This Service Information bulletin supersedes SI B33 04 09 dated October 2008.

The differential input flange mating surface with the input drive pinion is insufficiently greased.

E82 and E88 (1 Series), all models

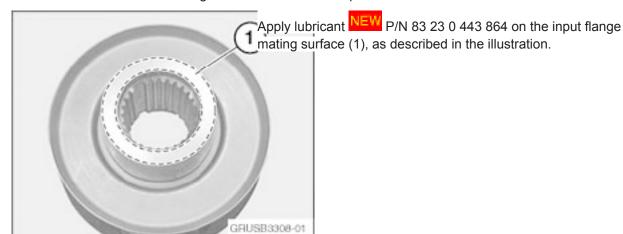
The customer complains that a single cracking or clicking noise can be heard from the rear of the vehicle while engaging a drive gear, releasing the clutch, during load reversal (shifting from reverse to drive, etc.), or when accelerating from a stationary position.

This is not a failure of the differential assembly. Do not replace the complete differential.

Remove the differential drive flange in accordance with Repair Instruction RA 33 11 021.

Before complete reassembly, replace the input flange seal and collar nut retaining plate as described in RA 33 01 021. Refer to the EPC for correct part numbers, based on model.
